CITY OF ALBUQUERQUE

RE: **Murphy Express. Carlisle & Phoenix**
2707 Carlisle Blvd. NE
Grading & Drainage Plan, **Rev. 1** for Building Permit

H16-D083A2

Based upon the information provided in your submittal received 12-19-2013, the above referenced Grading & Drainage Plan, **Revision 1**, is approved for Building Permit.

**GRADING &
DRAINAGE PLAN**

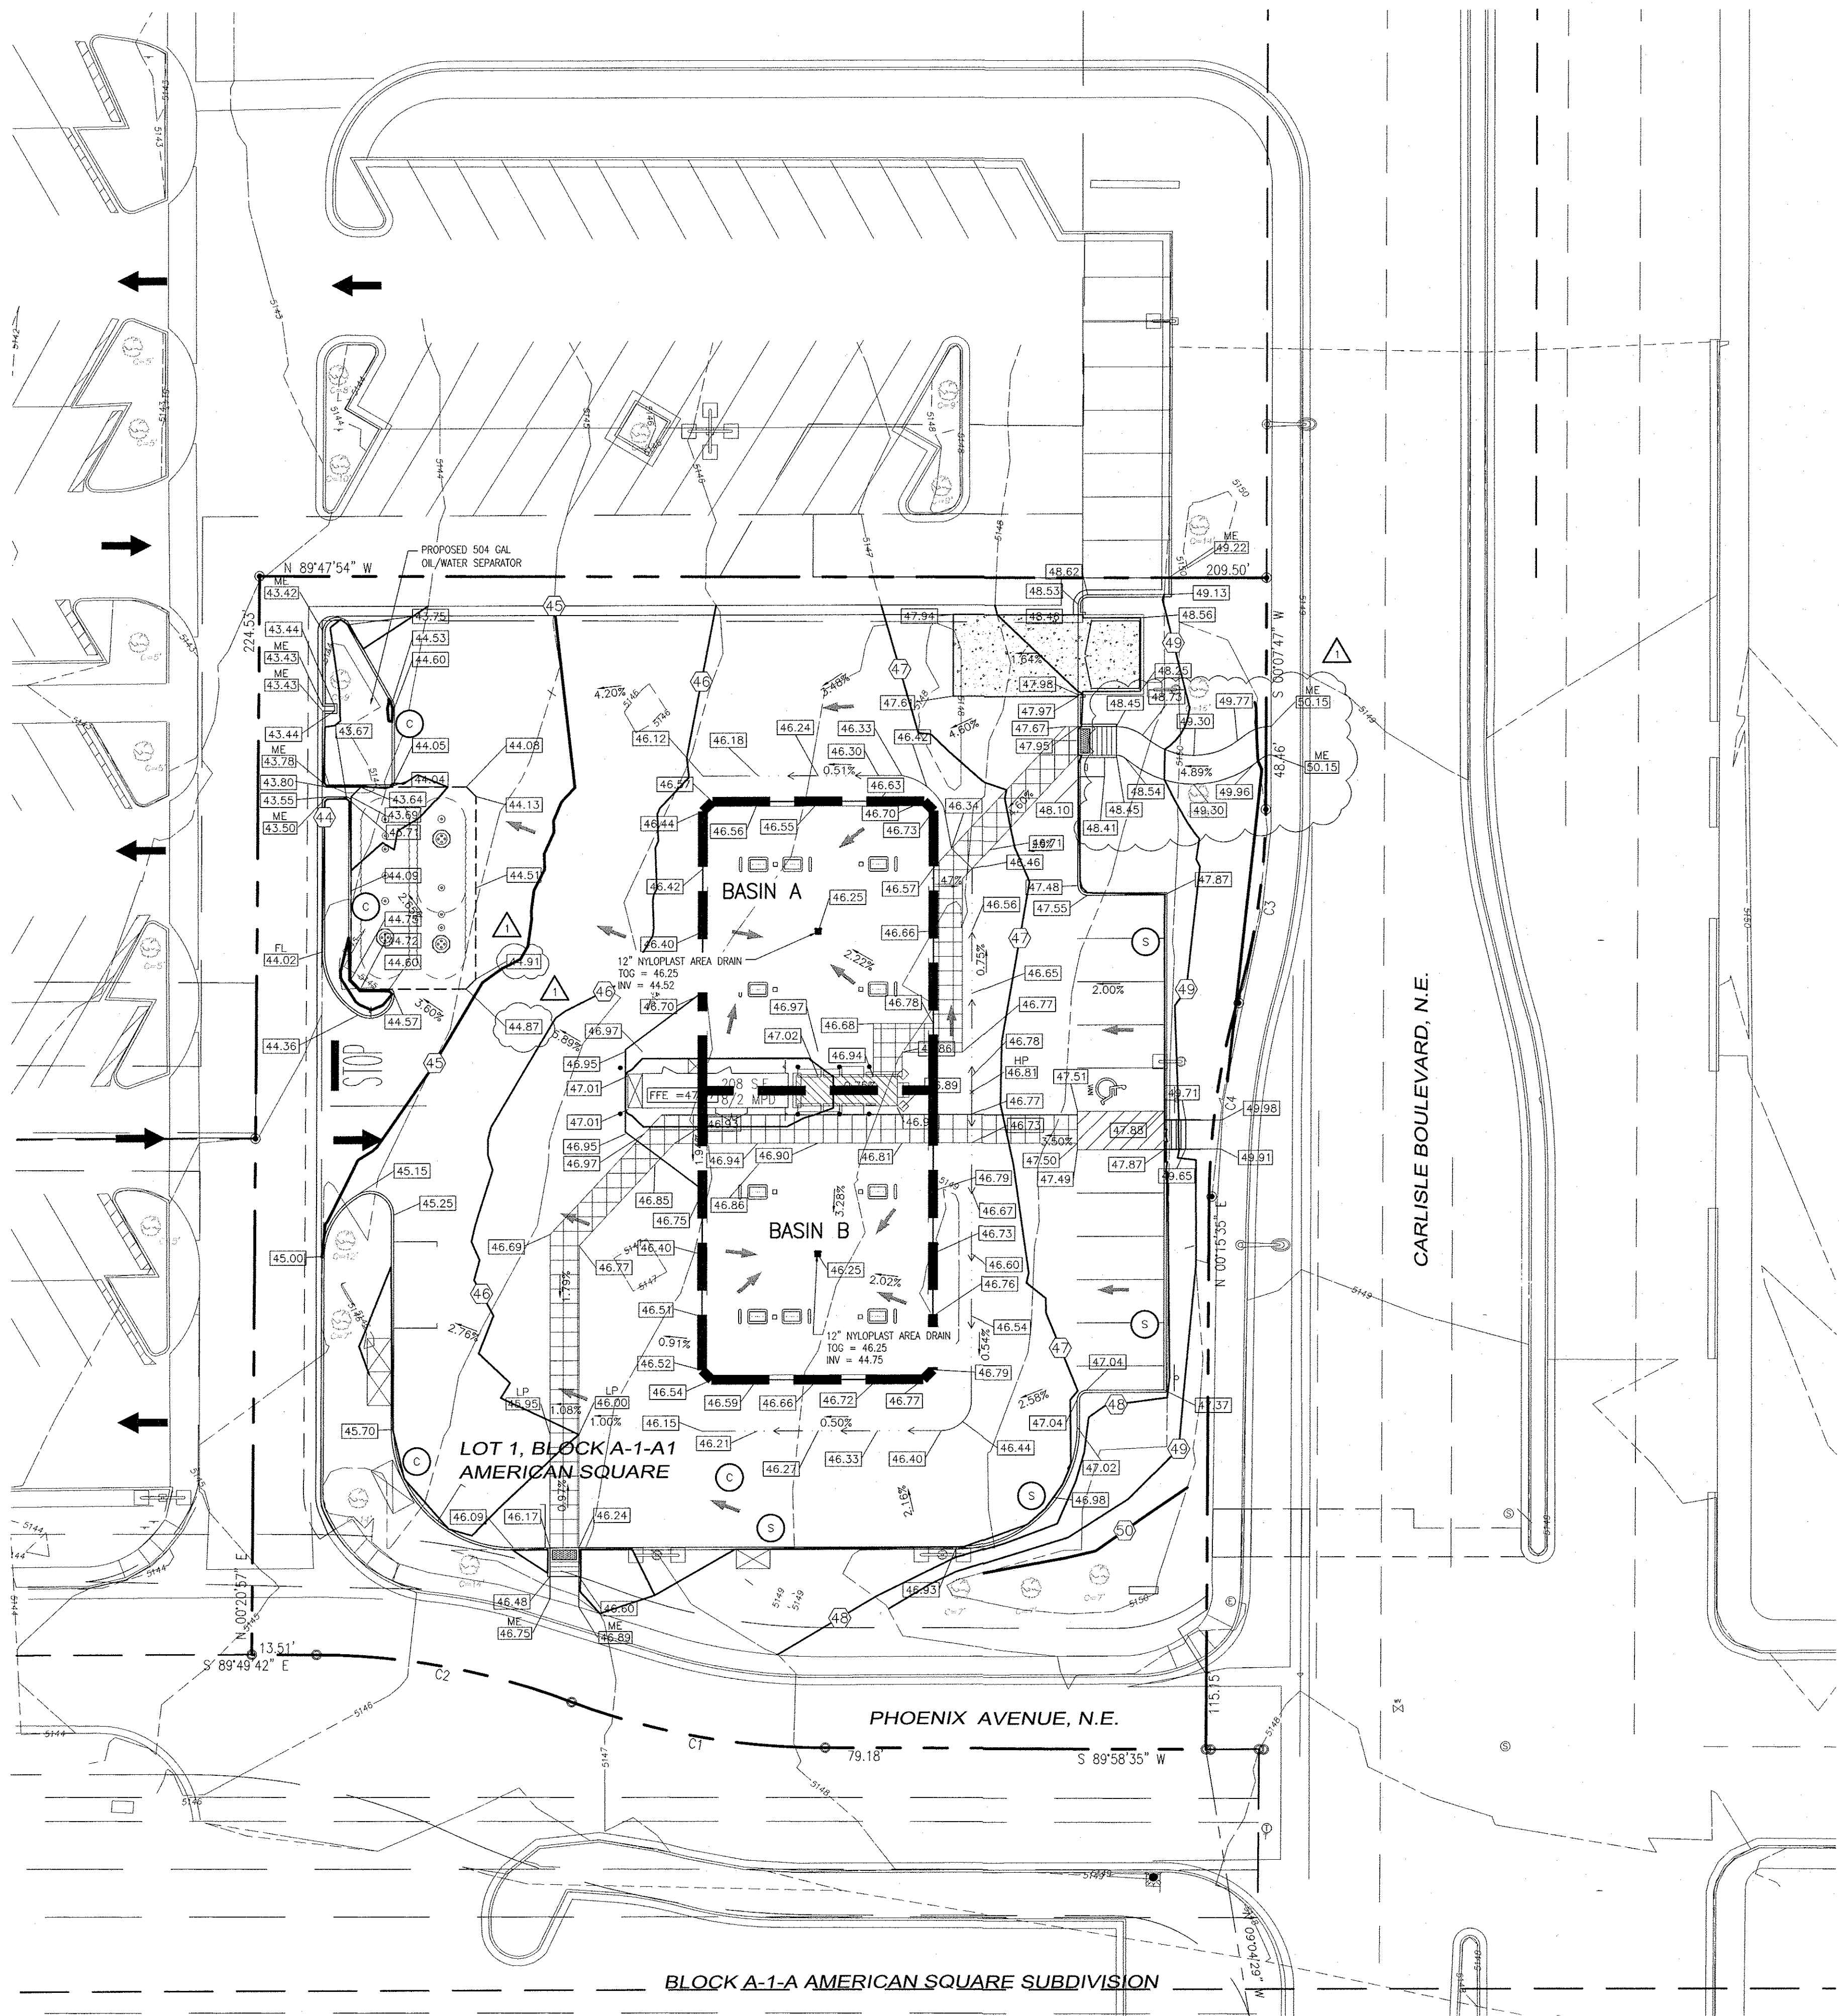
PO Box 1293 Please attach a copy of this approved, revised plan to the Building Permit, construction sets prior to requesting sign-off by Hydrology.

Albuquerque Prior to Certificate of Occupancy release, an Engineer's Certification of the As-Built grading and drainage at the site, will be required, per the DPM checklist (Chapter 22).
